**STAFF ANALYSIS  
OF THE  
NORTH AMETHYST  
SATELLITE TIE-BACK  
PROJECT**

The purpose of this Staff Analysis is to assess Husky's North Amethyst Development Plan Application and to make a recommendation to the Board. Staff's analysis considered safety, environment, resource management and socio-economic impact aspects of the Application.

Figure 4.7: Pressure vs Depth graph of White Rose Area (Source Husky)

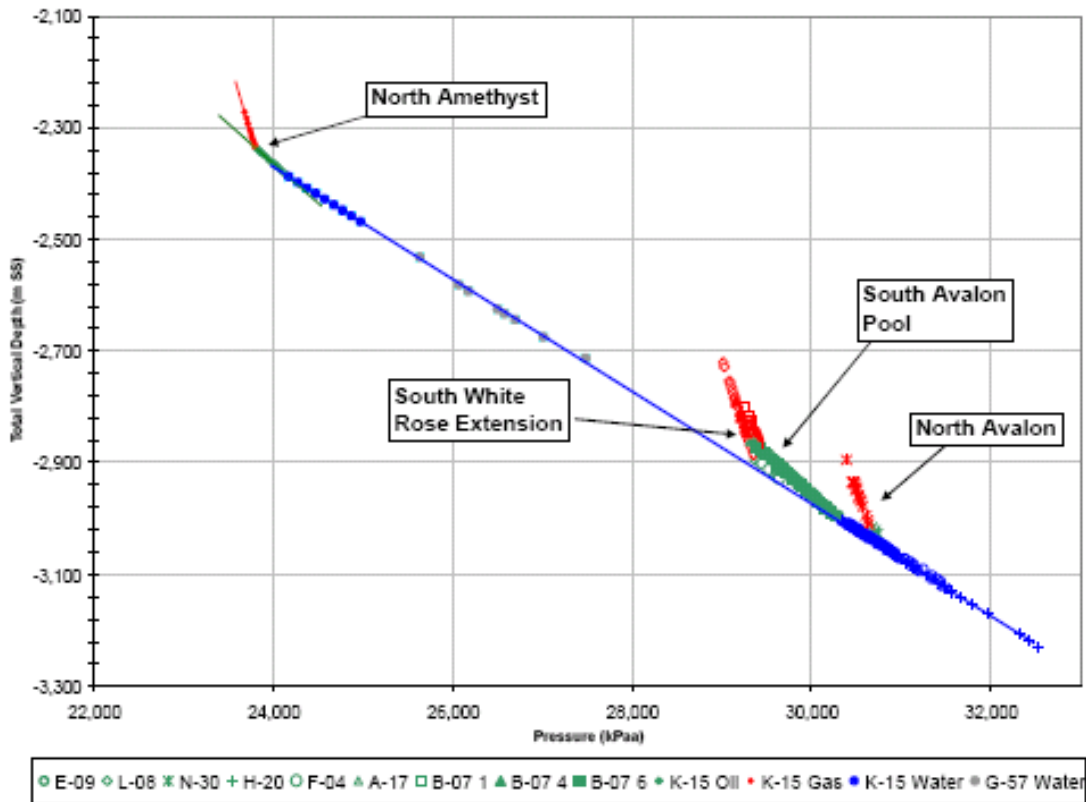
The reservoir pressure observed at the K-15 well was 23,800 kPa @2333 mTVDss. The gas, oil and water gradients observed at the K-15 well were 1.83 kPa/m, 7.01kPa/m and 9.90 kPa/m, respectively (Figure 4.7).

To investigate whether North Amethyst is a separate field from White Rose, Staff reviewed and compared the pressure data acquired from White Rose wells with the K-15 pressure data, and are satisfied that the North Amethyst oil is separate from the White Rose accumulations.

Figure 4.8: Proposed North Amethyst Well Locations (Source Husky Development Plan 2007)

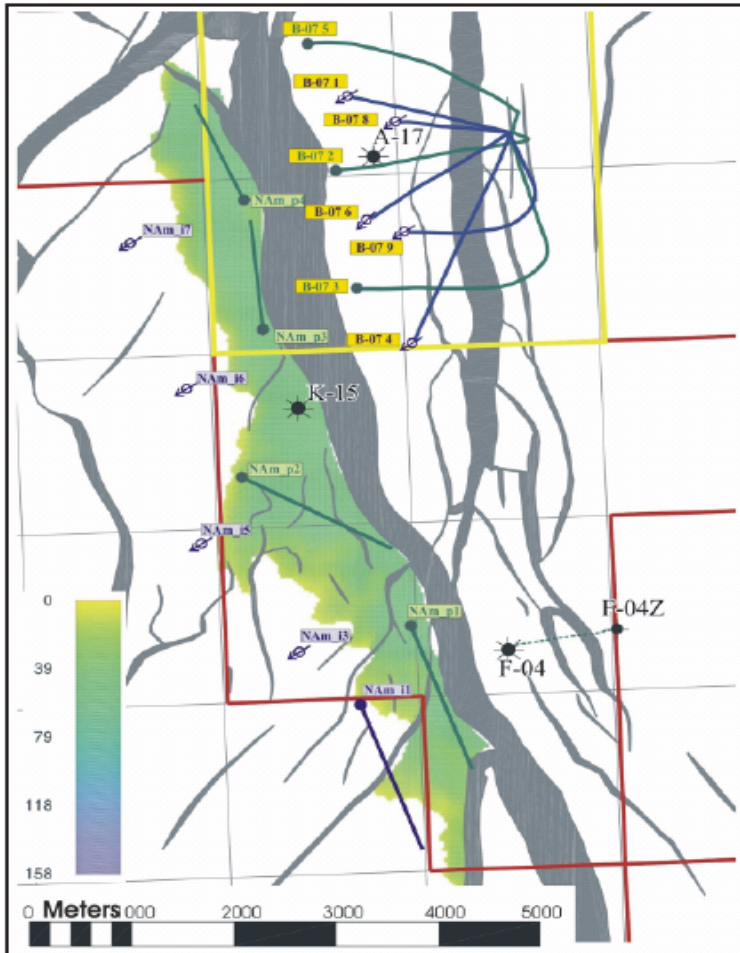
The Proponent indicates that four horizontal producers, with support from five water injectors, will provide optimal drainage of the North Amethyst Field. (Figure 4.8) Because the reservoir is interpreted as unfaulted and continuous, there is a reliance on long reach horizontal production wells to achieve and sustain reasonable oil production. The proposed production wells trend northwest-southeast and are placed updip near the eastern boundary fault in the midpoint of the oil column. Proposed vertical water injection wells are located west of the oil producers, and are placed downdip in the water

**Staff reviewed the Proponent’s displacement strategy for the North Amethyst Field and concurs with the depletion plan.**

**Figure 4.15: Oil Production from North Amethyst field with and without gas lift (Source: Husky)**

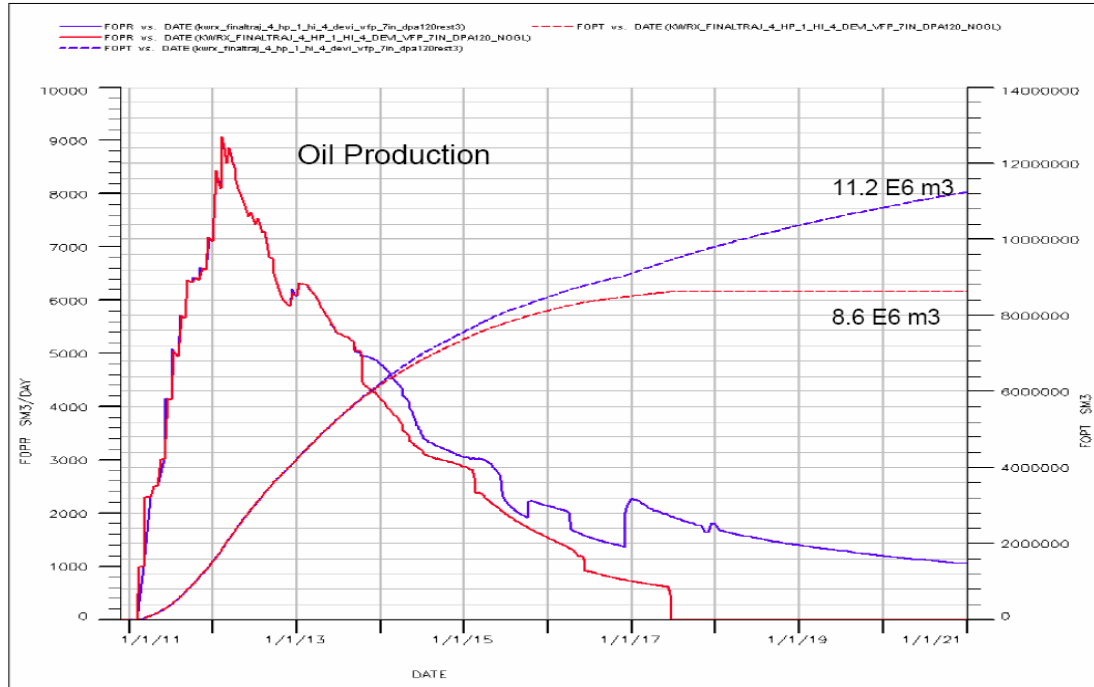
The maximum gas lift rate profile for the full field model is 1.6 x 10<sup>6</sup> m<sup>3</sup>/d. Gas lift is estimated to commence in both the North Amethyst wells by 2014. It is expected to commence in South Avalon pool wells in 2008-2009. Figure 4.15 depicts the importance of gas lift for optimum oil recovery within the field. Approximately 23 % of the recoverable reserves of North Amethyst field are dependent on the gas lift capabilities of the SeaRose FPSO.

Staff notes that the Proponent has not completed technical studies to optimize the field’s hydraulic performance. These studies will assess flow performance from the reservoir to the process facilities and include an assessment of the effects of the current FPSO location on oil recovery. Staff will require submission of these studies prior to finalizing the design concept.

**Figure 4.19: Full Field White Rose Gas Production Forecast, (South Avalon, SWRX and North Amethyst production) (Source: C-NLOPB)**

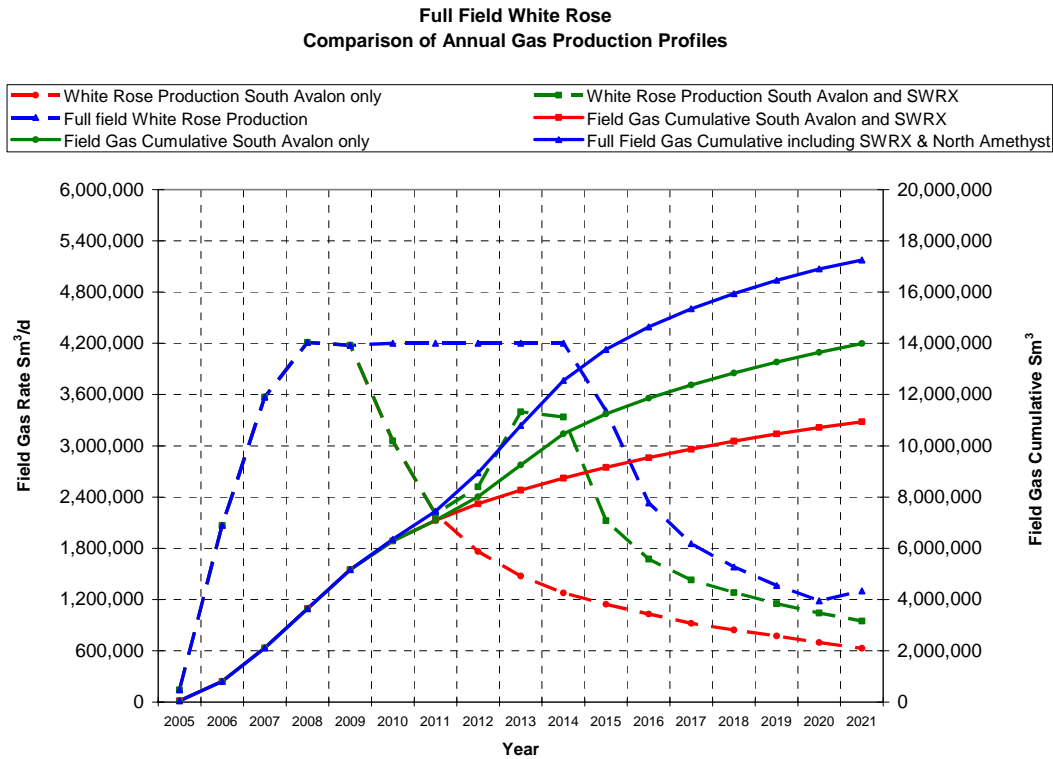
The Proponent’s gas production forecast (Figure 4.19) reaches a maximum daily gas rate in 2008 of 4.2 x 10<sup>6</sup> m<sup>3</sup> /d, which is the SeaRose maximum facility gas compression capacity. For 2007, the average daily total gas production was 2.5 x 10<sup>6</sup> m<sup>3</sup> /d, increasing to 3.0 x 10<sup>6</sup> m<sup>3</sup> /d in the last four months. The most recent gas production is 75% of the maximum daily gas rate.

Staff have reviewed the full field gas production forecast for the White Rose field and conclude that the Proponent's current gas storage plan is inadequate. The Proponent must

**Figure 4.20 : Combined North Amethyst and South Avalon Average Monthly Gas Plot ) (Source: Husky)**

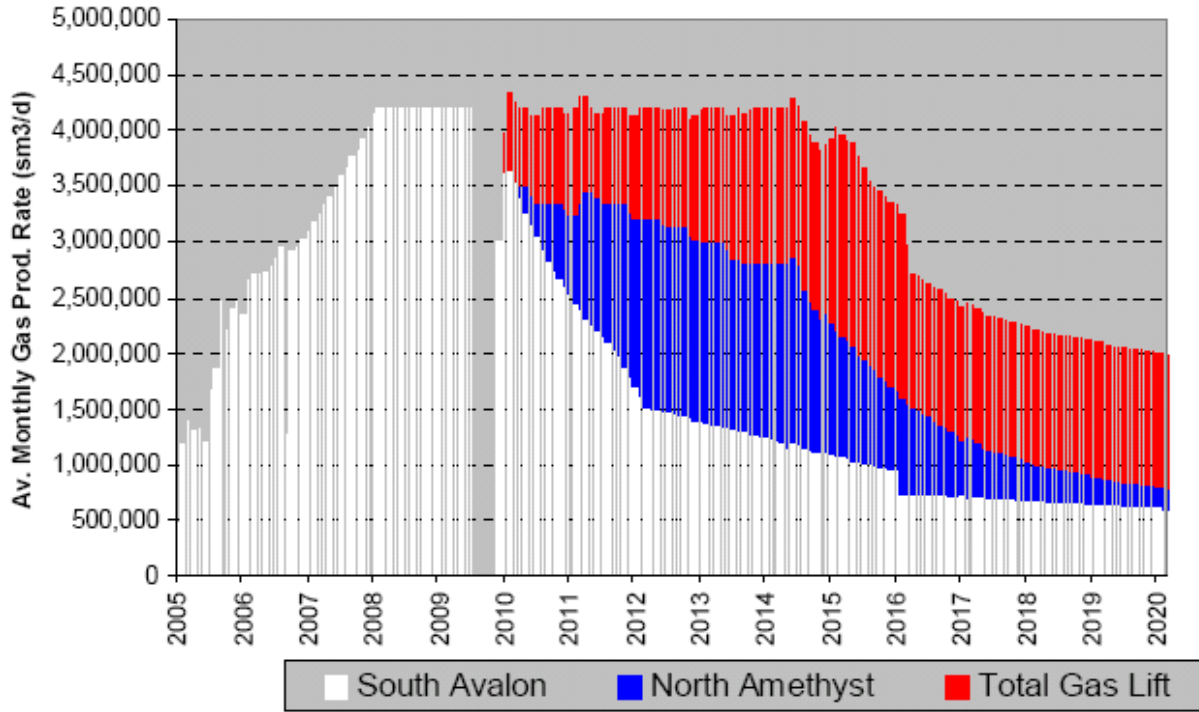
The Proponent has shown in Figure 4.20 that the reason that gas compression capacity is maximized is due to the introduction of gas lift in 2010 which will be utilized by both North Amethyst and South Avalon wells.

Staff note that gas production from the full field forecast will plateau for six years, due to North Amethyst Field performance exceeding a GOR of 600 Sm<sup>3</sup>/m<sup>3</sup>, before producing 20% of its original oil in place.
